Access Compliance Report

Public Rights-of-Way

Intersection ID: N/A	Main Street: E 8TH ST	Cross Street: N BREVARD ST	Location: N
ADA ID: 2E9BB8D6C5B5	Ramp Type: Perp	Initial Pass/Fail: Fail	Overall Compliance: No
Severity Score: 21.25			
Codes/Mitigation Info/Possible Solution		Field Measurements/Component Compliance

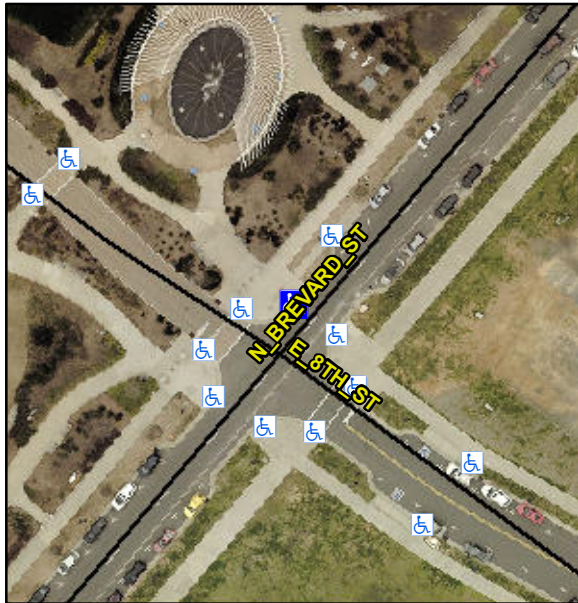
R304.5.1, R304.2.2

Compliance	Description	Data	Compliance	Description	Data
N/A	Ramp Length (in)	71.0	No	Ramp Slope (%)	9.6
No	Ramp Width (in)	39.0	Yes	Ramp XSlope (%)	0.3
N/A	Flare Type LT	N/A	N/A	Flare Type RT	N/A
N/A	Flare Slope LT (%)	N/A	N/A	Flare Slope RT (%)	N/A
N/A	Flare Traversable LT?	No	N/A	Flare Traversable RT?	No
N/A	Landing Length (in)	N/A	N/A	DWS Provided?	N/A
N/A	Landing Width (in)	N/A	N/A	DWS Contrast?	N/A
N/A	Landing Slope (%)	N/A	N/A	DWS Length (in)	N/A
N/A	Landing X Slope (%)	N/A	N/A	DWS Full Width?	N/A
N/A	Landing Curb? (Y/N)	N/A	N/A	DWS Offset (in)	N/A
N/A	Shared Landing?	N/A			
N/A	Gutter Ponding?	N/A	N/A	Gutter Slope (%)	N/A
N/A	Gutter Lip Ht (in)	N/A	N/A	Gutter X Slope (%)	N/A
N/A	Painted X Walk1?	No	N/A	Painted X Walk2?	N/A
	X Walk 1 Direction	To SE		X Walk 2 Direction	N/A
N/A	X Walk 1 Width (in)	N/A	N/A	X Walk 2 Width (in)	N/A
	X Walk 1 Slope (%)	1.5		X Walk 2 Slope (%)	N/A
	X Walk 1 X Slope (%)	0.6		X Walk 2 X Slope (%)	N/A

Remove & Replace Entire Ramp.
